prepaAppendix 1. Taharoa Ironsands Ltd Request for Information

Substantive Application

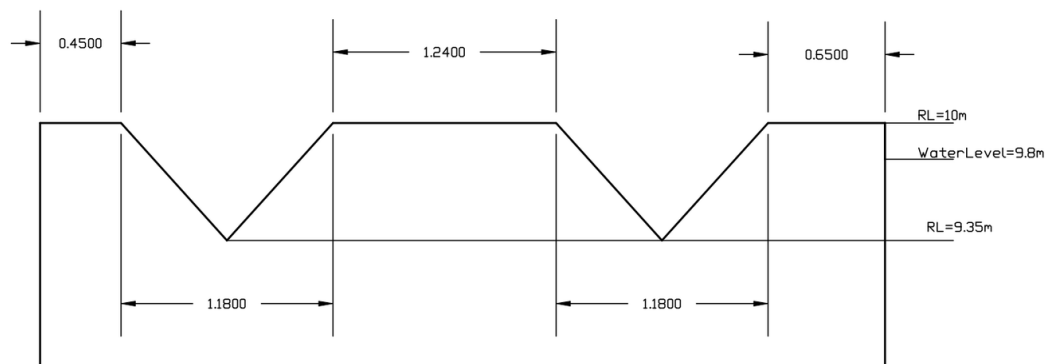
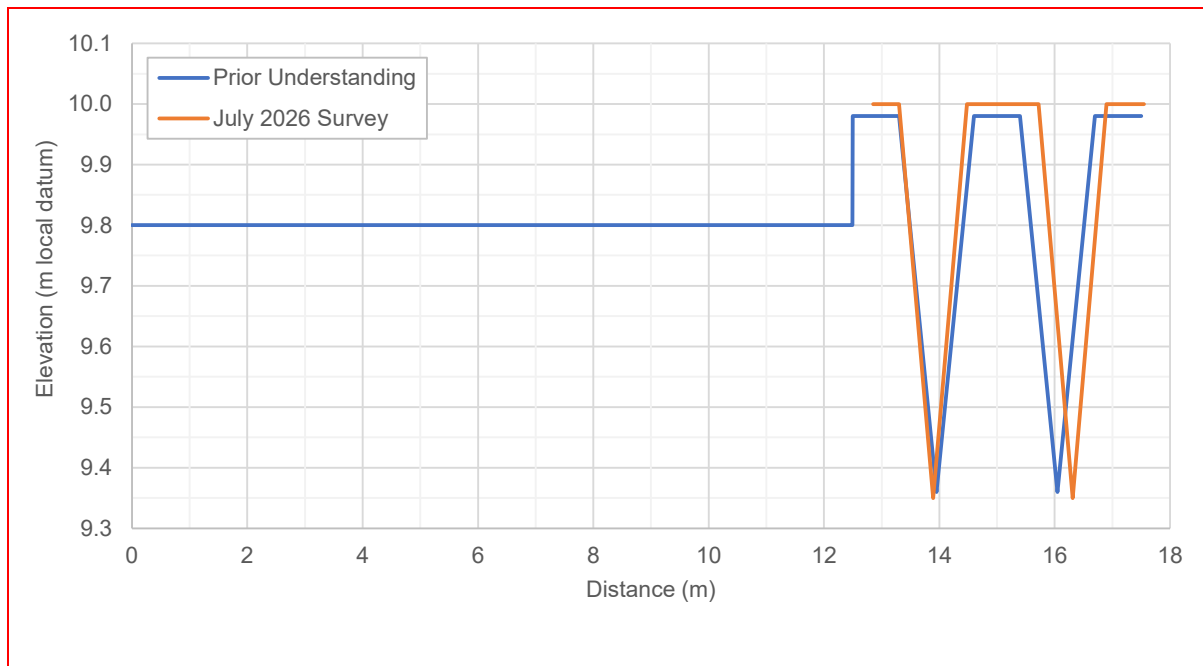
*“The outlet weir has reportedly been upgraded and modified on a number of occasions since construction in the late 1970’s. There do not appear to be any current as-built or design drawings that reflect the current state of the structure which is shown in **Figure 11**”.*

“As seen in Figure 6 the lowest water level measured behind the dam structure was 9.45 m RL in early 2014. This is equivalent to 0.09 m head above the invert of the two v-notches in the weir structure (Figure 12). Applying a standard weir flow calculation, the flow through the outlet weir at this level would have been 10 L/s.”

This residual flow was set based on the minimum record water level behind the dam (9.45 m) based on the ~12 years of data available, and the corresponding flow rate of 10 L/s calculated using a standard v-notch weir equation based on the weir configuration detailed in Section 4.3.5 of the Hydrology Assessment. The calculation was based on TIL's best understanding of the weir dimensions in its current form at the time of preparing our assessment.

In response to this question from the Panel, TIL resurveyed the weir, and were successful in obtaining accurate dimensions of the two v-notch components of the weir. The surveyed dimensions are illustrated in the schematic below.

This matches relatively closely to our prior understanding of dimensions, and is compared to the schematic used in our assessment (Figure 12 – Appendix I) below. Key differences of note are:

- The 2026 survey has a slightly lower invert at 9.35 m RL (compared with the prior value of 9.36).
- The 2026 survey has a shallower v-notch angle at 84.5 degrees (compared with the prior value of 92 degrees).
- The separation between the two v-notches is 0.44 m wider (note – this has no effect on flow through the two v-notches).

The flow through the two v-notch weir sections at water level of 9.45 m RL (at the weir) (equivalent to 0.1 m head above the invert) is 10 L/s. Hence there is no change to the minimum flow requirement through the weir. The slightly lower invert level from the July 2026 survey dimensions in combination with the shallower v-notch angle results in the same flow rate (rounded to the nearest 1 L/s) as previously determined.
